# Old Woodward Ave & W Maple Road

## Streetscape Design

Presentation | February 2, 2017

# Revisions To The Design Concept Per The City Commission

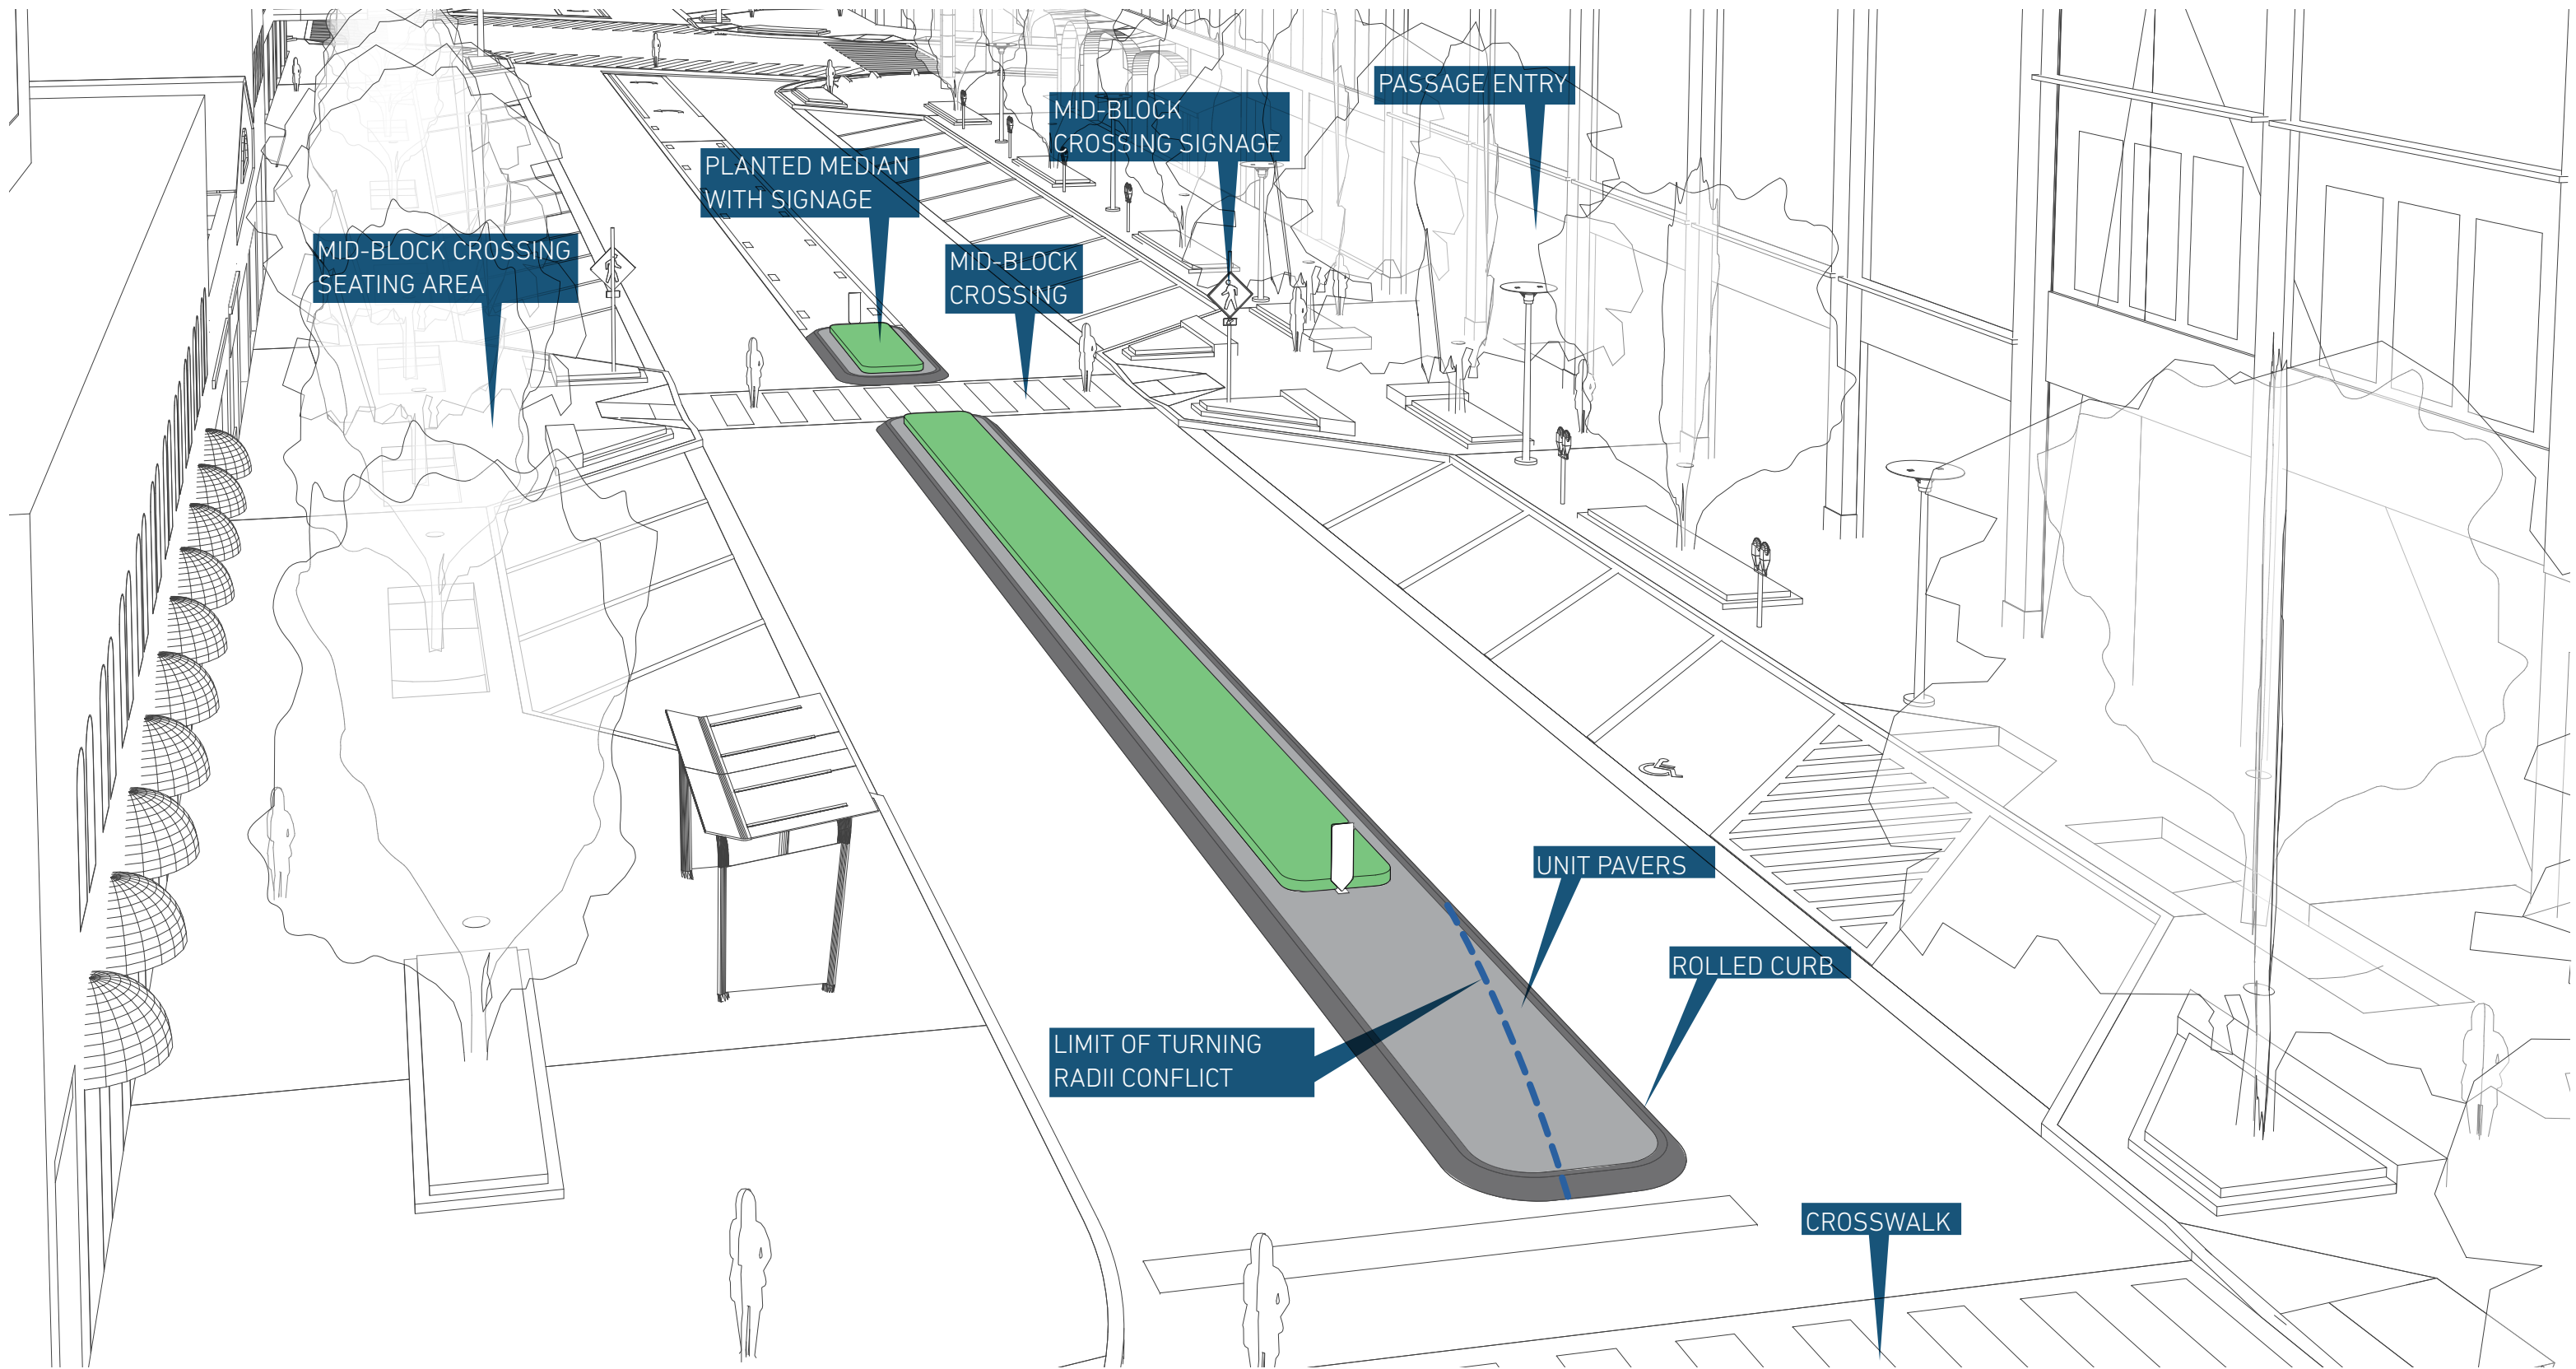
- » Add planted medians to Old Woodward Ave center turn lane; Hamilton Row & Old Woodward Ave, Merrill Street & Old Woodward Ave
- » Add protective median islands where possible at crossings to protect pedestrians; Maple Road & Pierce Street (alley access)
- » Relocate mid-block pedestrian crossing at East Maple to the Cafe Via passage
- » Study the possibilities of narrowing Old Woodward mid-block crossing to add parking

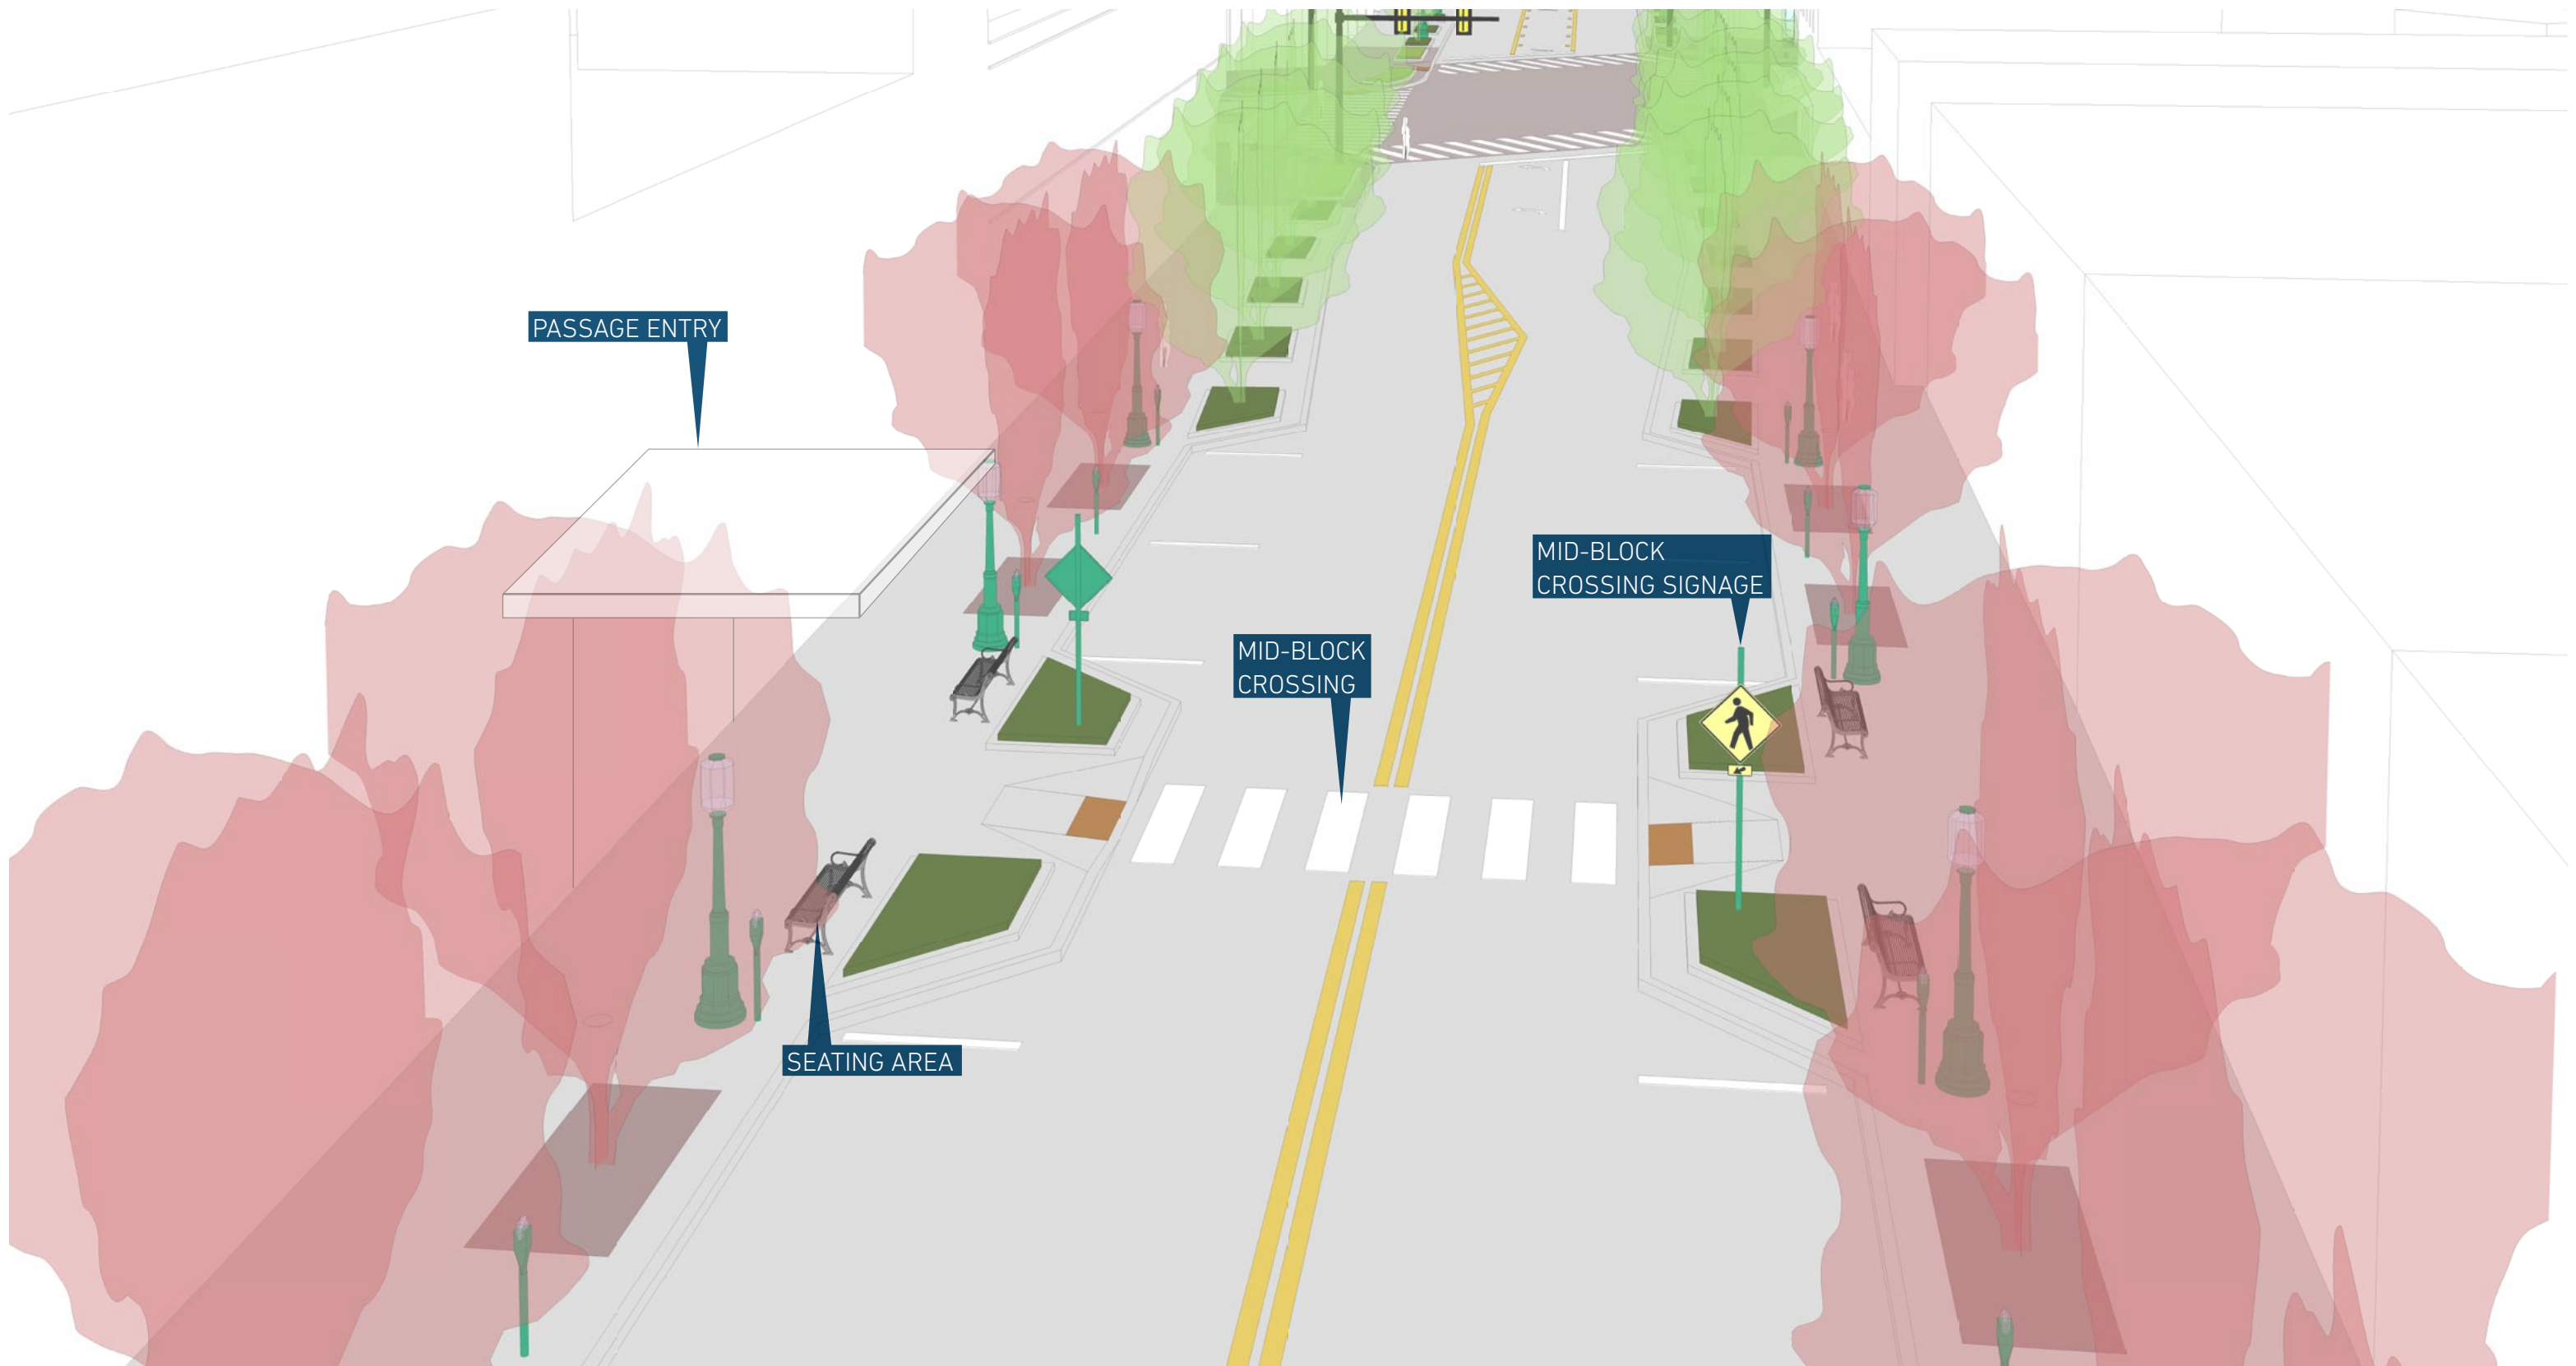
- » CROSSING IS 10'-0" WIDE (8'-0" MIN WIDTH) PER MULTI-MODAL STANDARDS PROPOSAL
- » CANNOT REDUCE CROSSING WIDTH DUE TO a) VISIBILITY ISSUES WITH CROSSING BETWEEN CARS AND b) REDUCING CROSSING WIDTH WILL NOT ALLOW ENOUGH SPACE TO ACCOMMODATE ADDITIONAL PARKING
- » 4 TOTAL PARKING SPACES REMOVED

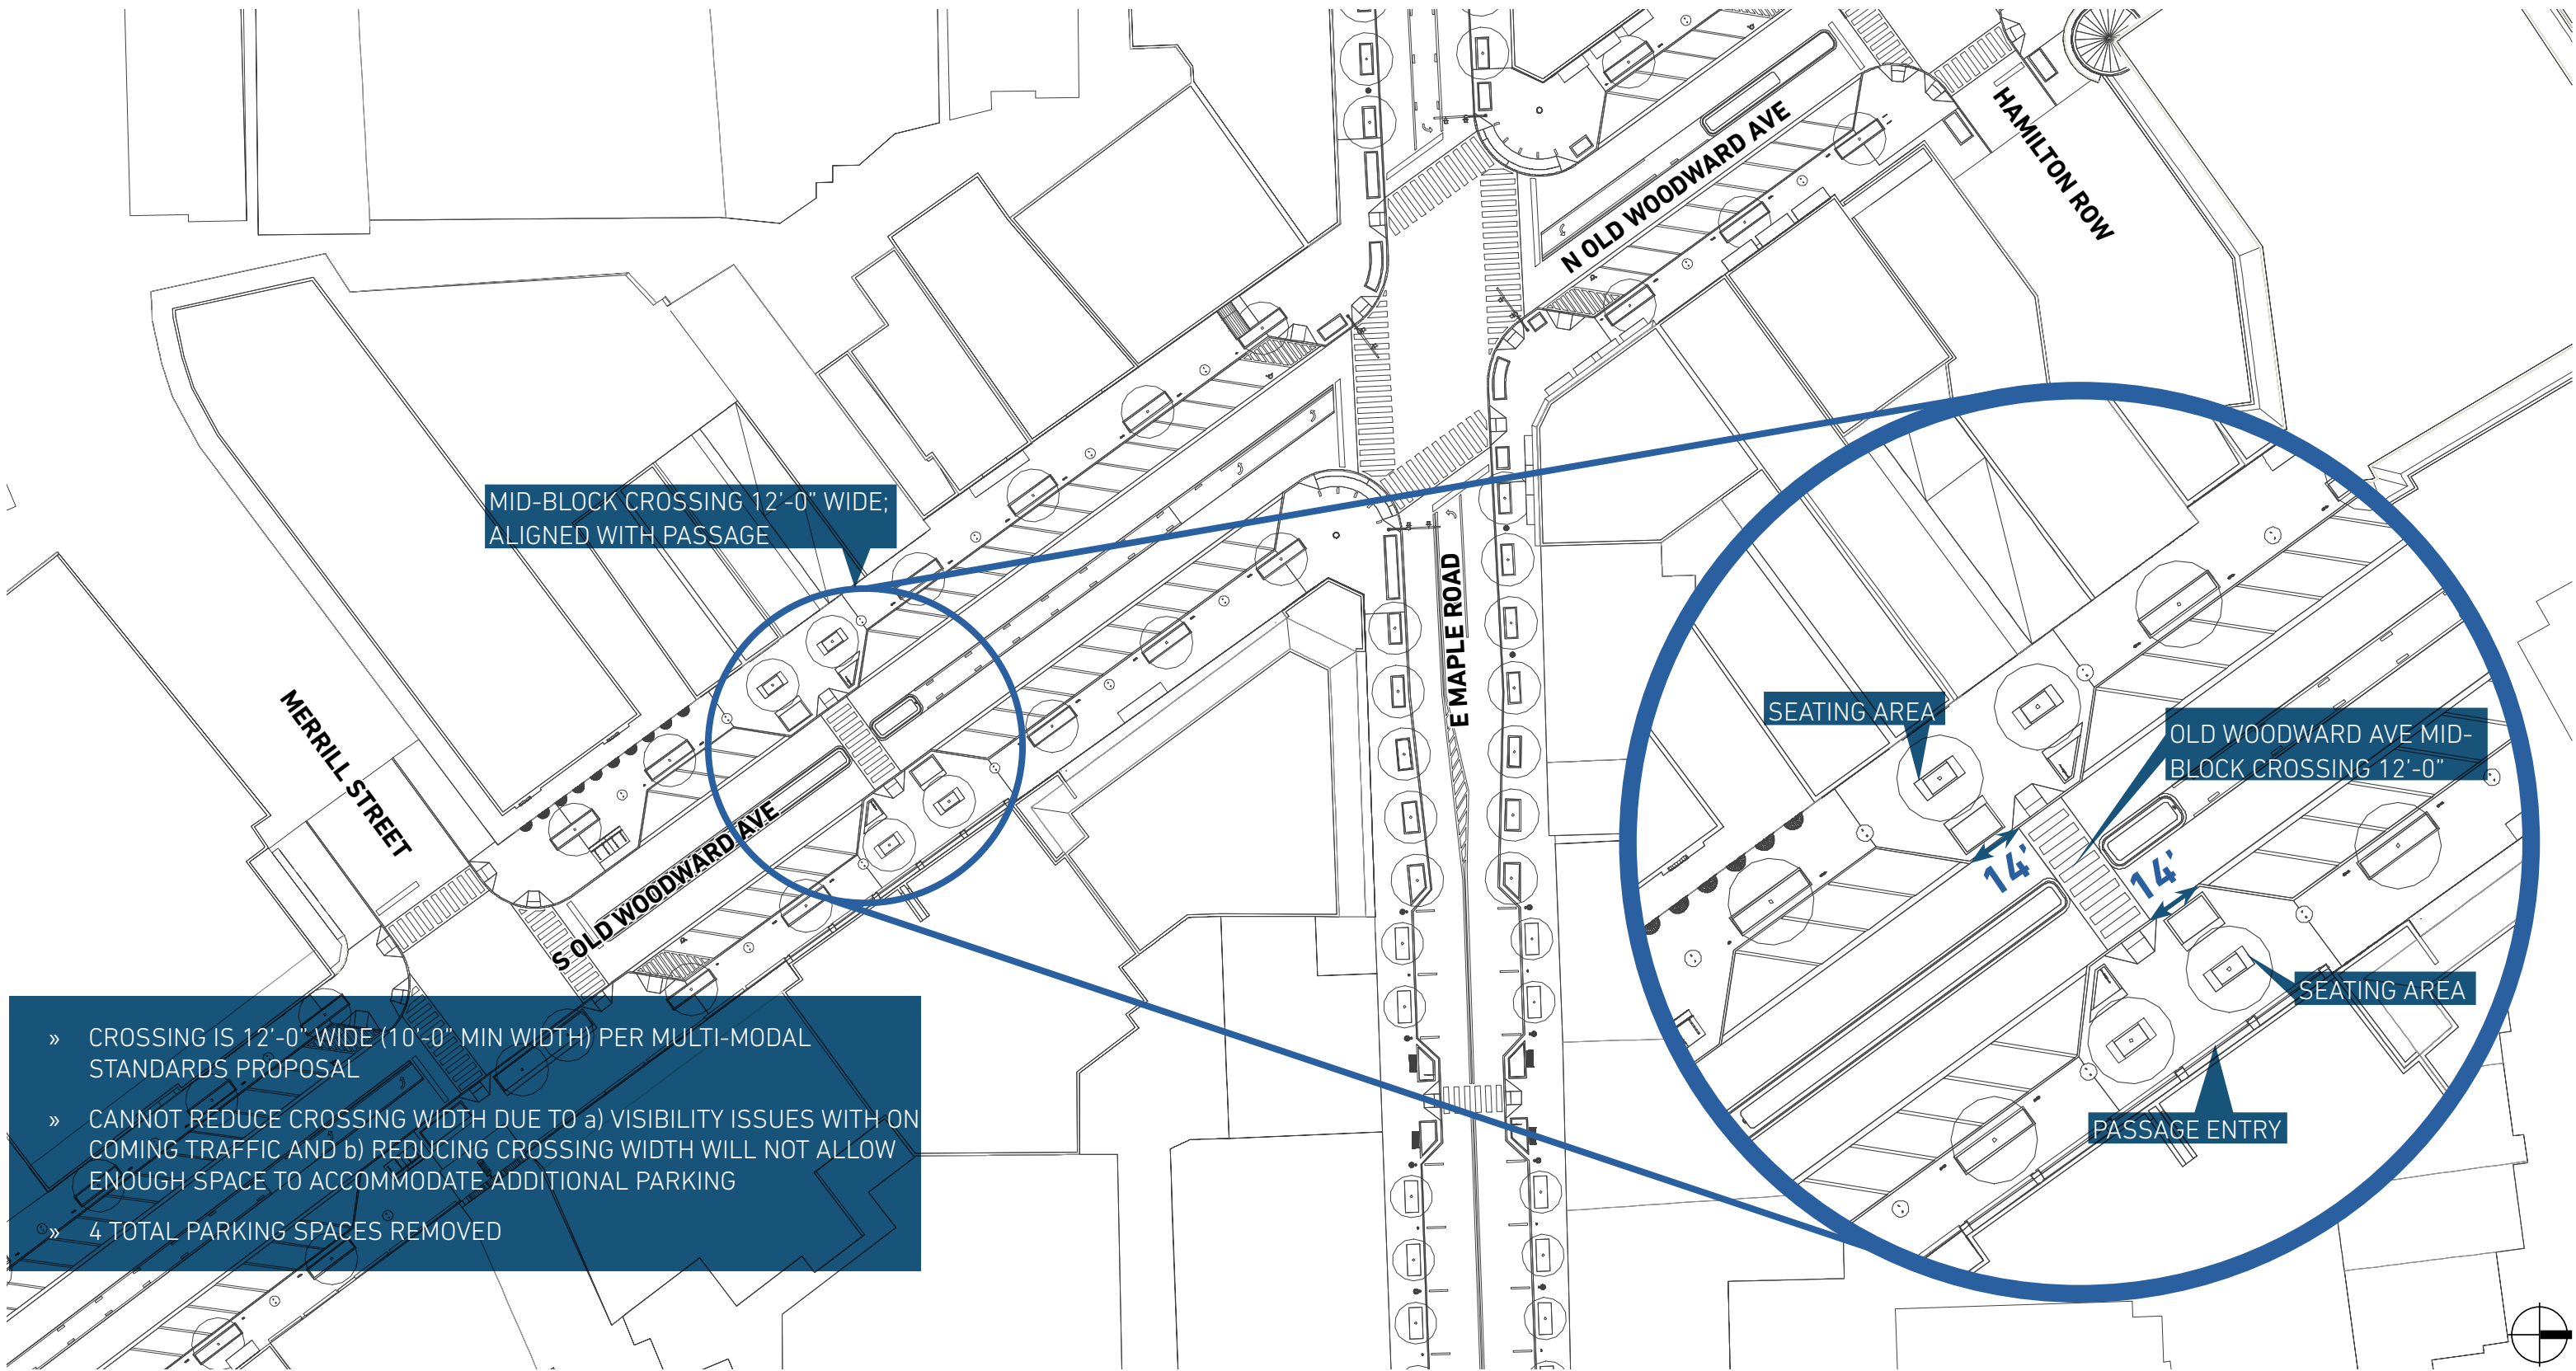
- » CROSSING IS 12'-0" WIDE (10'-0" MIN WIDTH) PER MULTI-MODAL STANDARDS PROPOSAL
- » CANNOT REDUCE CROSSING WIDTH DUE TO a) VISIBILITY ISSUES WITH ON COMING TRAFFIC AND b) REDUCING CROSSING WIDTH WILL NOT ALLOW ENOUGH SPACE TO ACCOMMODATE ADDITIONAL PARKING
- » 4 TOTAL PARKING SPACES REMOVED
